Queensland Competition Authority

Final decision

Aurizon Network 2014 draft access undertaking
Volume III—Pricing & tariffs

April 2016

Figure 2 Aurizon Network's proposed socialisation test in the 2014 DAU

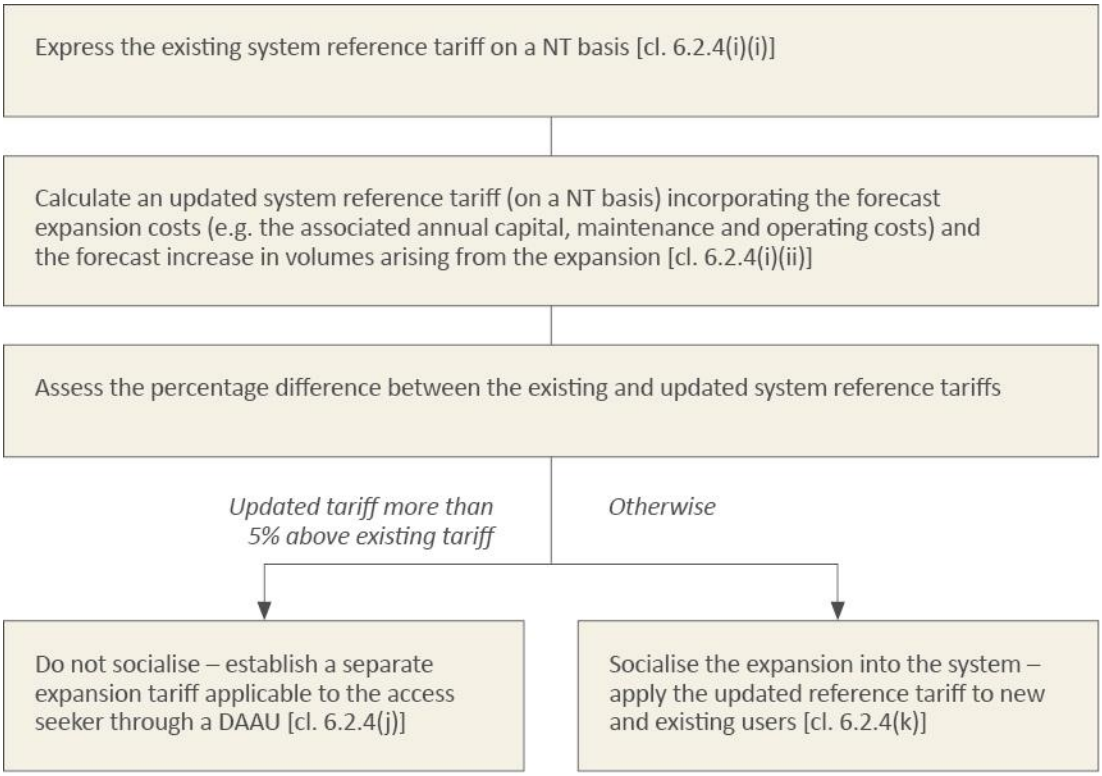
The proposed socialisation test in the 2014 DAU is presented in the figure below, assuming the relevant coal system has only one reference tariff, which is the system reference tariff, and the expansion is not expected to benefit existing users of the system (i.e. no cost allocation to existing users is required).

Aurizon Network said an expansion tariff does not include a contribution to common costs of the system—meaning, in cases where a separate expansion tariff is established, expanding users will not be required to pay more than the full incremental costs arising from their access to the CQCN.[161]

Figure 4 Aurizon Network 2013 GAPE DAAU

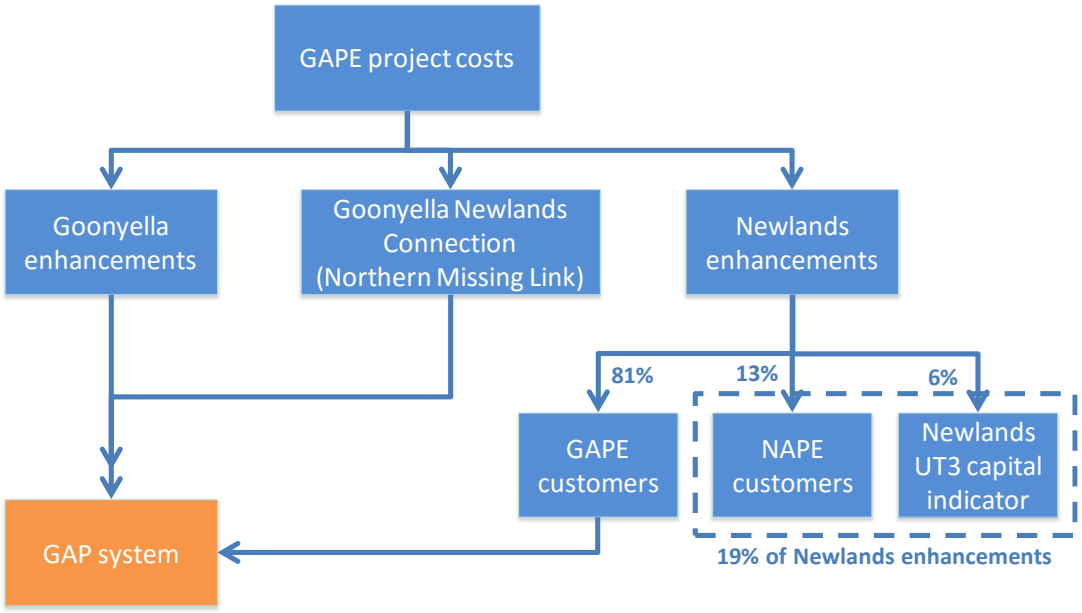
However, in the pricing model underlying its 2014 DAU, Aurizon Network allocated 19 per cent of Newlands enhancement costs solely to NAPE Deed customers. Aurizon Network also proposed that an additional $30.3 million[368] be allocated to Newlands as discussed above. Given its 2014 DAU proposal to socialise NAPE costs within the Newlands system, this results in a total Newland enhancement costs allocated to the Newlands system of approximately 23 per cent (19 per cent plus the $30.3 million discussed above). The figure below summarises Aurizon Network's 2014 DAU modelling approach.

QCoal proposed that, should the QCA reject Aurizon Network's proposal to allocate the $30.3 million to Newland's system customers, this cost should be included in the top level GAPE

Figure 6 QCA proposed allocation of GAPE project costs

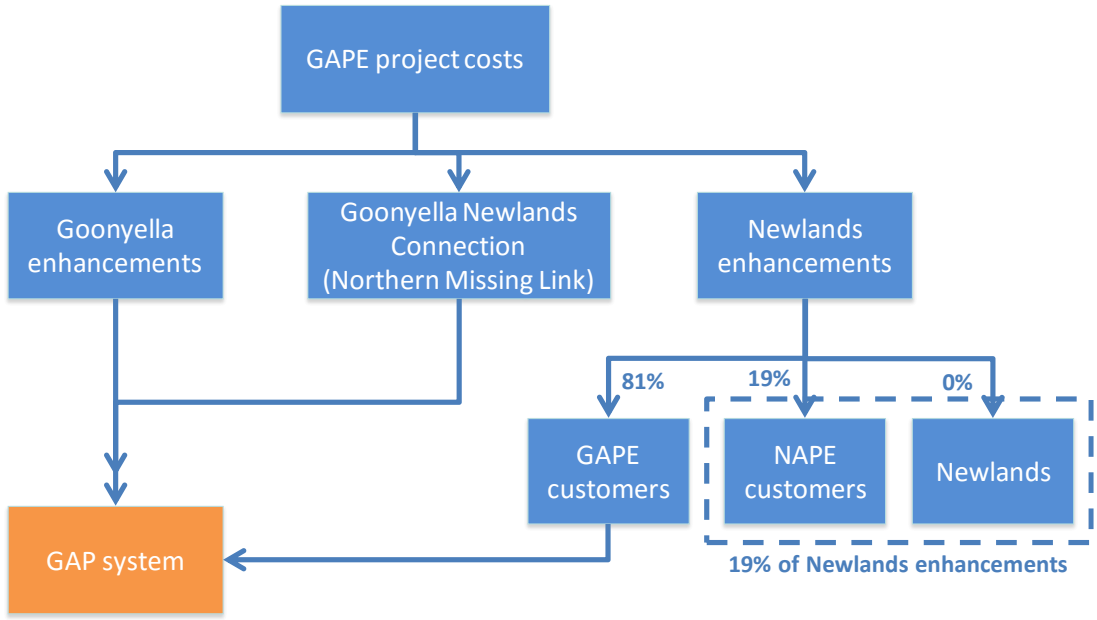
Our consolidated draft decision was to allocate the costs to GAPE and NAPE Deed customers as shown in the figure below.
